**WOODFORD COUNTY BOARD OF EDUCATION
AGENDA ITEM**

TOPIC/TITLE: Change Order #9

WCHS Phase 1: Change Order #09 Summary

Firewall Modification

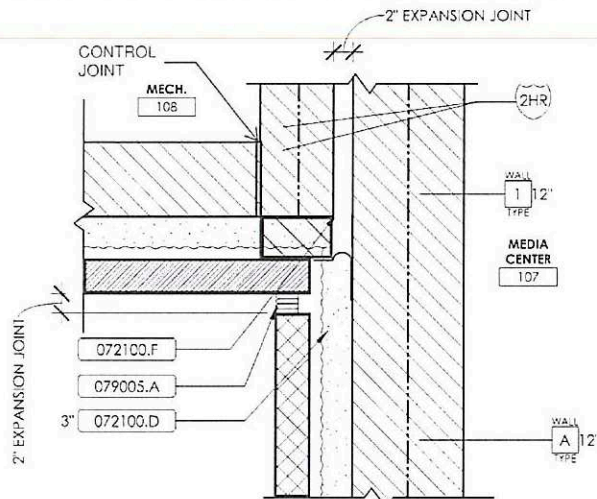
- a) Revise inside corners at all firewall locations to be similar as shown in attached detail.
